January 11, 2016  
LINCOLN PUBLIC SCHOOLS  
NUTRITION SERVICES – FOOD STORES WAREHOUSE  
AND HUMANN ELEMENTARY TEMP. SCHOOL  
LINCOLN, NEBRASKA

-----  
**ADDENDUM #1**

**Project:** LPS Food Store  
**Project No.:** 15-080  
**Addendum No.:** 1  
**CC:**

**LPS FOOD DISTRIBUTION  
ADDENDUM #1  
RETAINING WALL DETAIL**

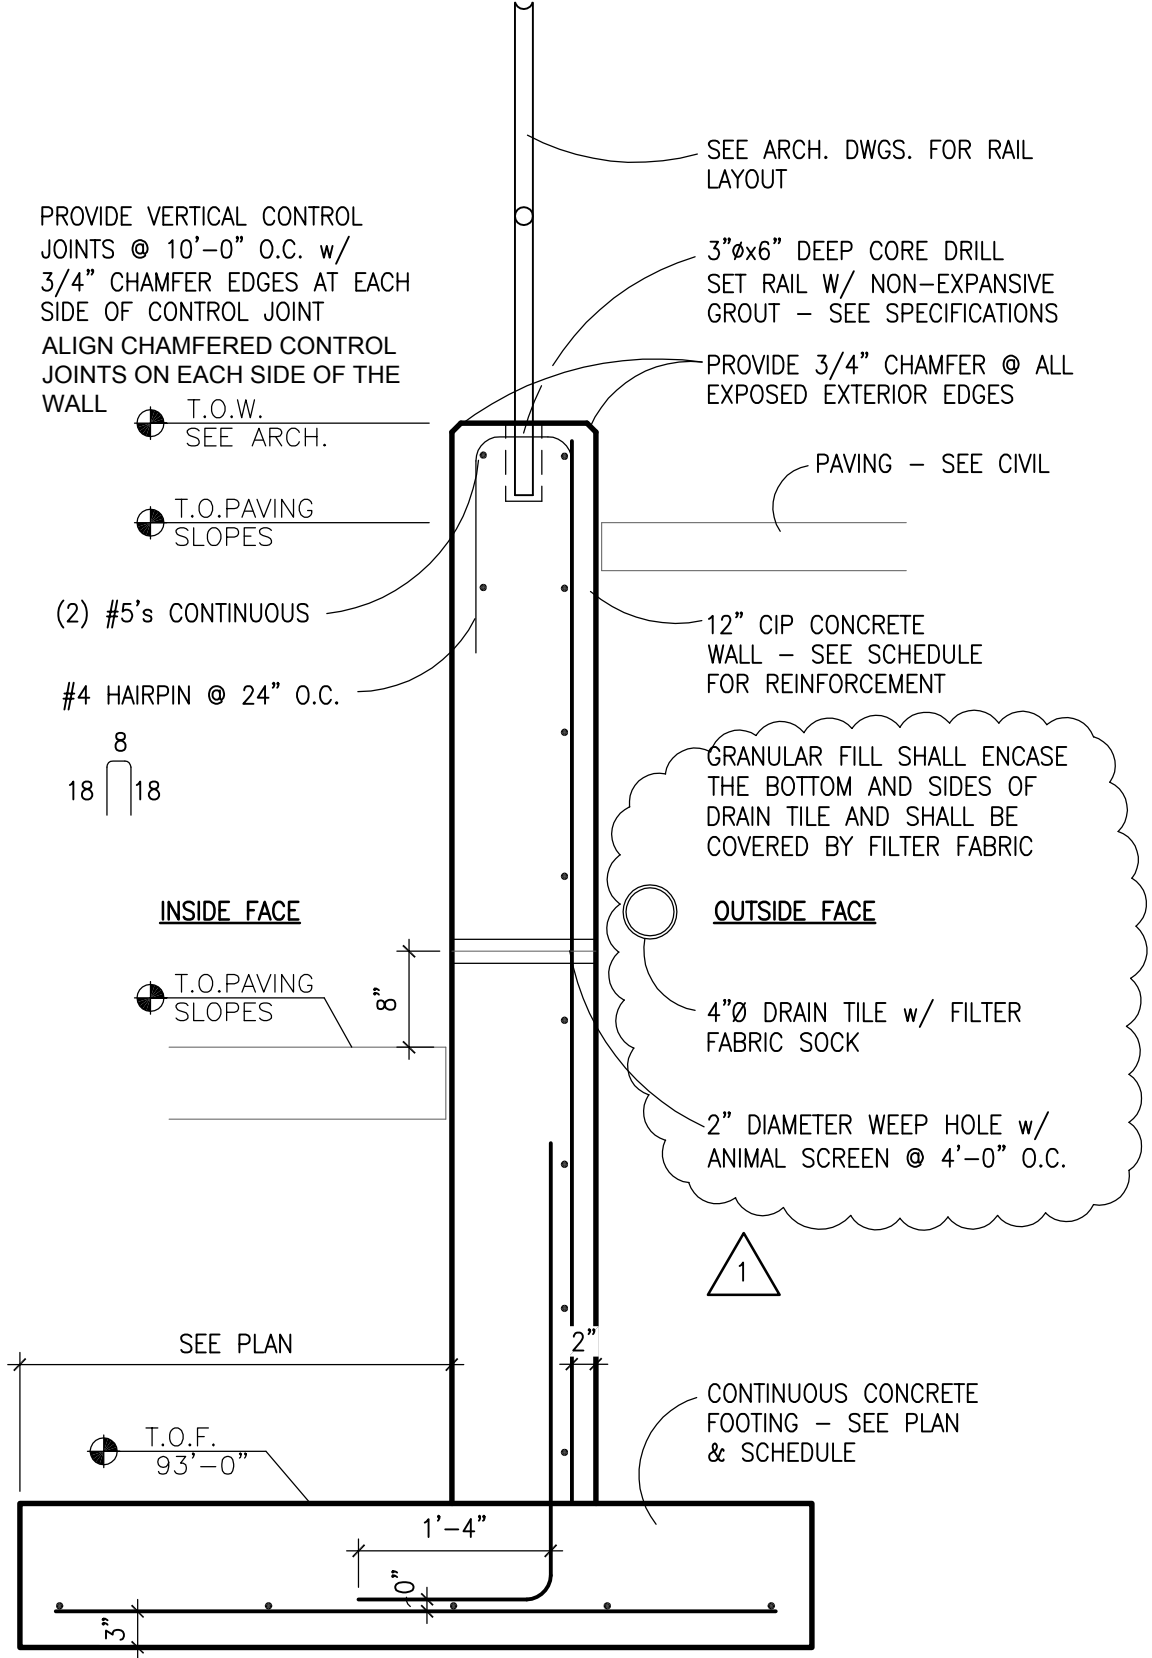
- D. At detail G10 'Typ. Retaining Wall', delete this detail and substitute the attached detail AD1-1 from SDG. This detail adds control joints, weep holes, drain tile, filter fabric and granular fill. Note that the drain tile is to run the full length of each of the 2 retaining walls and is to tie into the trench drain at the base of the retaining walls.

- THIS DETAIL REPLACES DETAIL G10/S3.2 OF THE CONSTRUCTION DOCUMENTS

## CONTINUOUS FOOTING/GRADE BEAM SCHEDULE

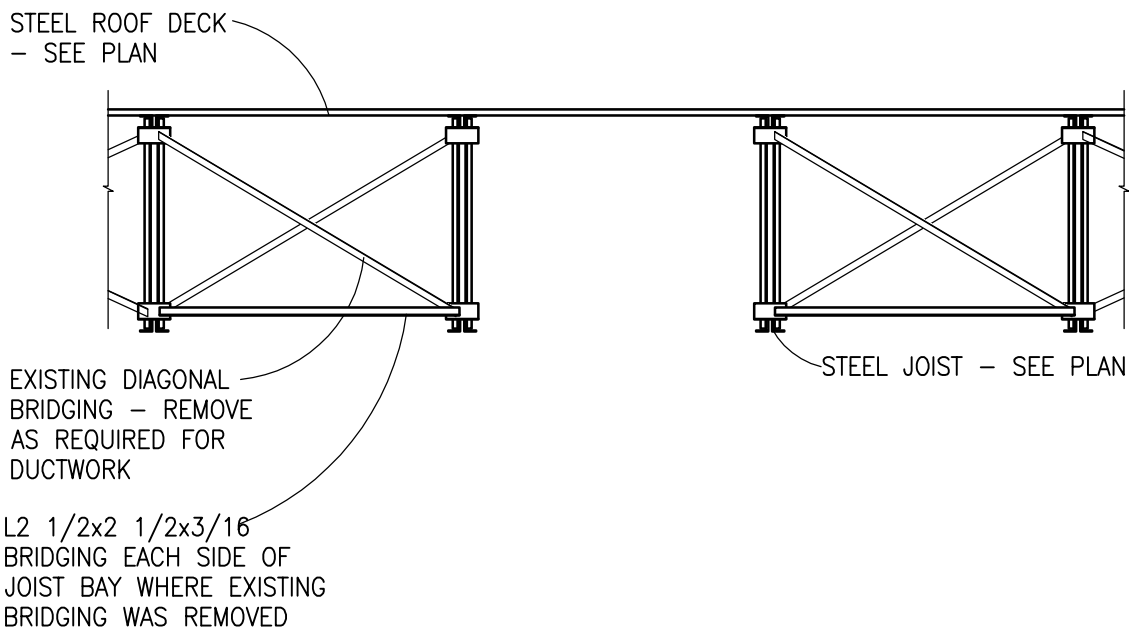
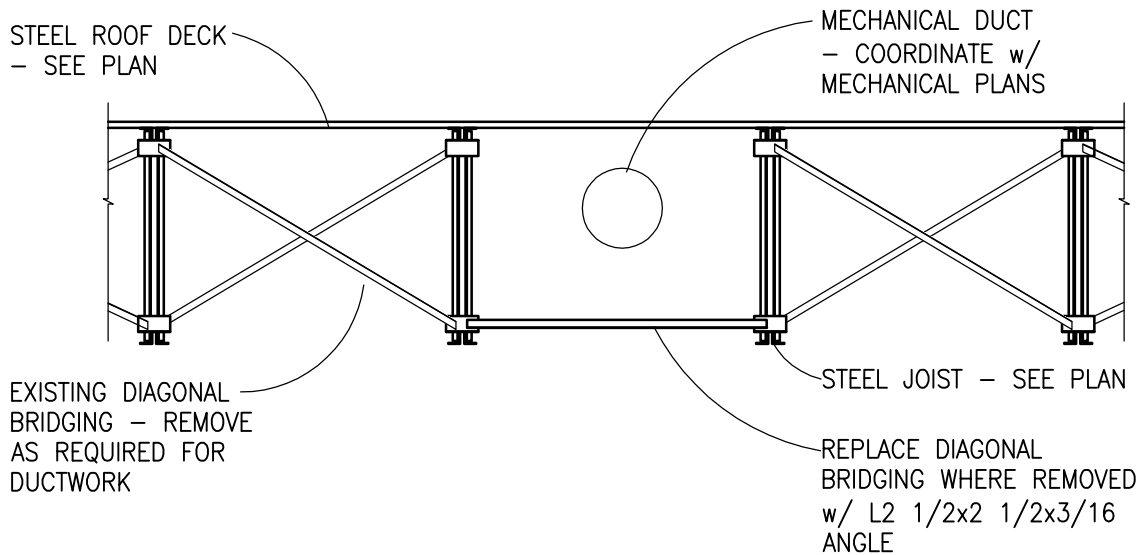
- A. At the 'Mechanical Equipment Suspended from Bar Joists' details, add a note at both details that the Uni-Strut is to be spot welded to the bar joists.
- B. At the 'Typical Forklift Charger Platform' detail, add a note that 2 platforms are required – see Architectural plan sheet A1.3 for locations.
- C. Add the attached detail AD1-4 'Joist Bridging Replacement' for the replacement of joist bridging where necessary. Also, add the following note: "Note: Bridging must be replaced where duct mains are shown to run up in the joist space, at the stair and ladder to roof location and where bridging conflicts with new construction."
- D. At the 'Continuous Footing/Grade Beam Schedule', delete this schedule and substitute the schedule on the attached page AD1-3 from SDG. This schedule adds grade beam GB 2-6C.

- ADDED LINE FOR GRADE BEAM GB 2-6C TO SCHEDULE

# PHASE I DEMO KE PLAN - SOUTH

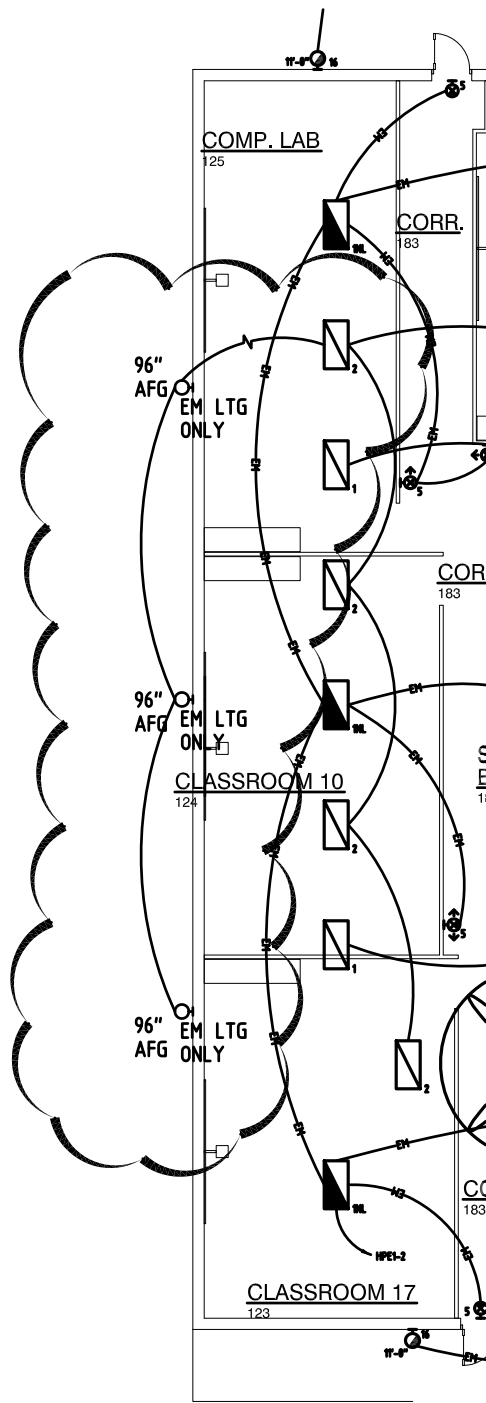
- 1) Existing Telephone Board to be removed in its entirety.
- 2) Electrical Contractor to remove existing Disco ball in its entirety. See attached drawing.

## PLAN - NORTH

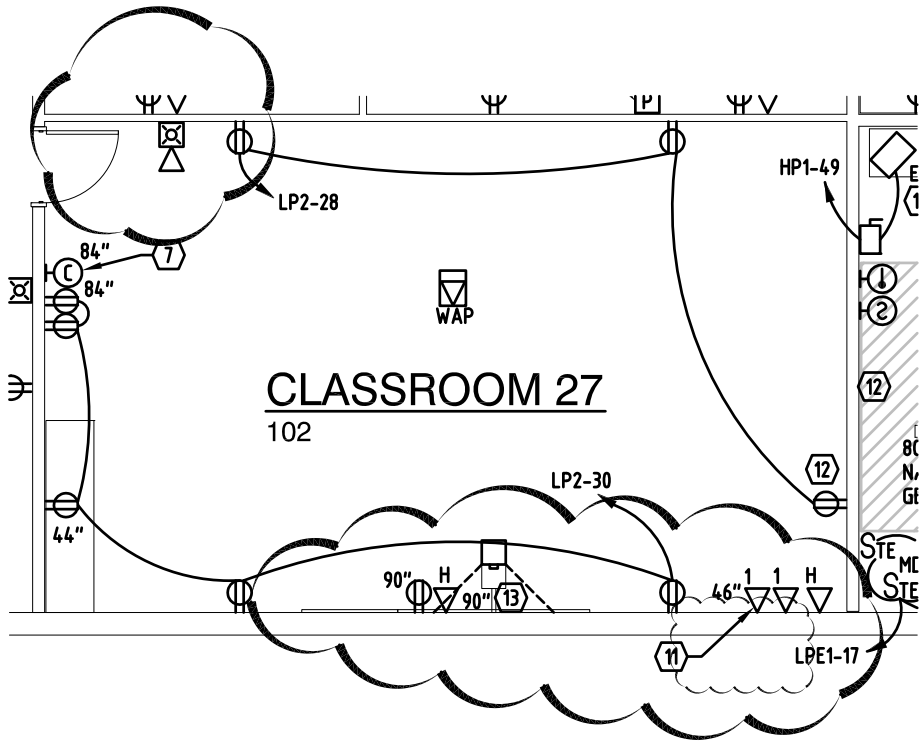
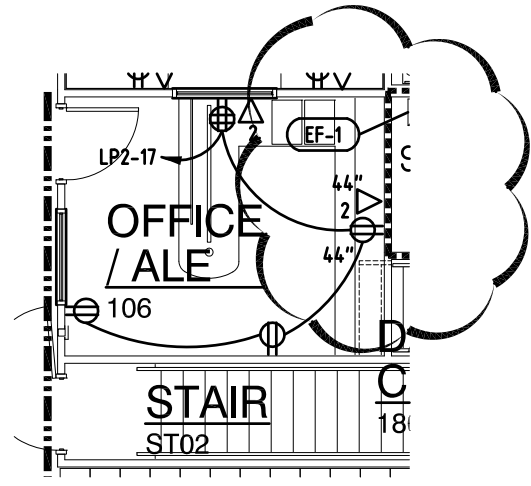
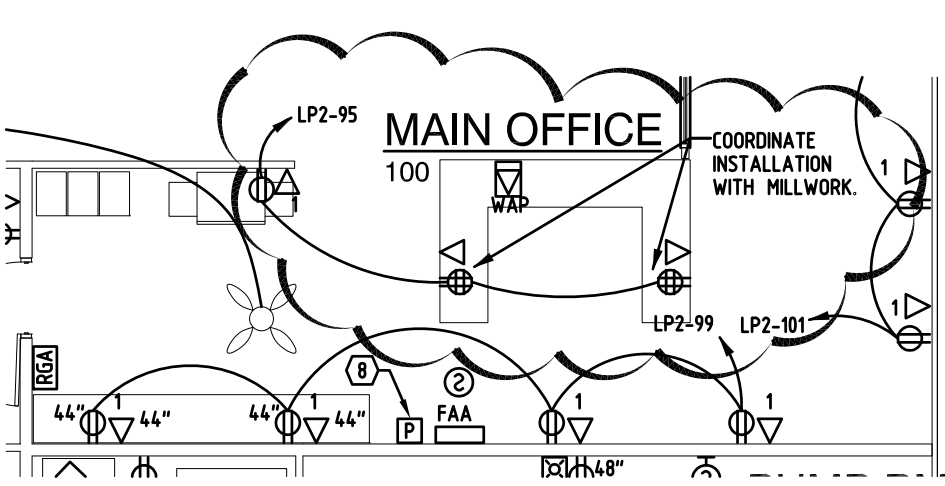
- 1) Provide and install 3 new Emergency light fixtures to north end of building. Fixture type shall be Lithonia # AFN W EXT. See attached drawing.

# PHASE 1 ELECTRICAL PLAN - SOUTH

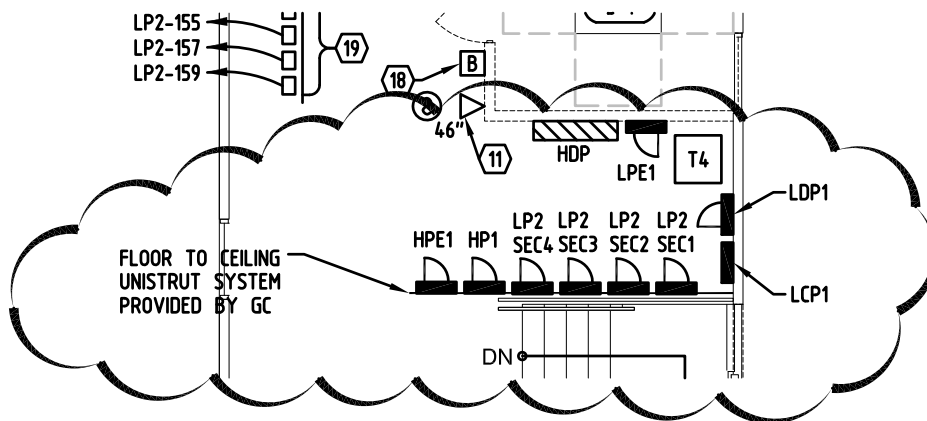
- 1) Office 106 – devices located on south wall shall be mounted at 44”. See attached drawing.
- 2) Main Office 100 – Provide and install 4-plex receptacles and data outlets to “U” shape desk. Coordinate installation with millwork. See attached drawing.
- 3) Classroom 27 – Provide Fire Alarm Horn/Strobe to East wall. See attached drawing.
- 4) Classroom 27 – Relocate all projector devices to West wall. See attached drawing.
- 5) Revise note C as follows – “ALL WIRING DEVICES AND CONDUIT MOUNTED ON TEMPORARY WALLS CAN BE SURFACE MOUNTED OR RECESSED – CONTRACTORS OPTION. ALL WIRING DEVICES AND CONDUIT MOUNTED ON PERMANENT WALLS MUST BE RECESSED. WALL TYPES 3 AND 4C ARE TEMPORARY – ALL OTHER WALL TYPES ARE PERMANENT – SEE SHEETS A1.1 AND A1.2 FOR WALL TYPE LOCATIONS.”
